# SWAG 33 10 5637, 33 10 5615

Mazda CX-7 2006 > 2014, CX-9 2007 > 2016,  
MX-5 2005 > 2014

## Brake Disc

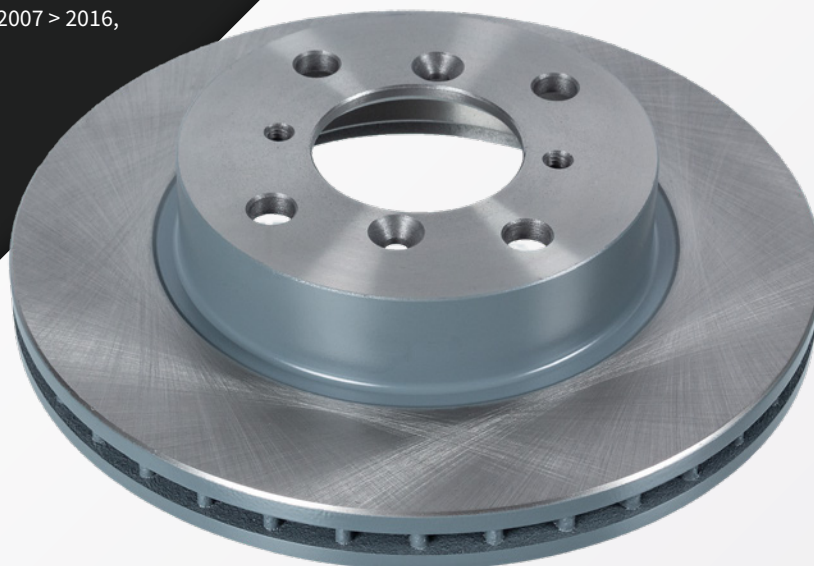
For the vehicle production period after October 2012, Mazda modified the design of the wheel hubs and brake discs - removing the retaining screw fixing points (on both the hubs and discs) as an effect.

As a result, and when replacing the front brake discs on the models listed above, it can be found that the brake disc is not secured to the wheel hub with retaining screws upon removal of the road wheel.

However, replacement SWAG brake discs 33 10 5637 and 33 10 5615 are manufactured with two retaining screw fixing holes - allowing SWAG brake discs to be compatible with vehicles made before and after the production date change.

33 10 5637 and 33 10 5615 can either be used with or without the retaining screws because the road wheel secures the brake disc to the hub once the wheel nuts are tightened to the correct torque.

Using a suitable torque wrench, the wheel nut should be tightened to:

CX-7: 103 ± 15 Nm

CX-9: 128 ± 15 Nm

MX-5: 103 ± 10 Nm
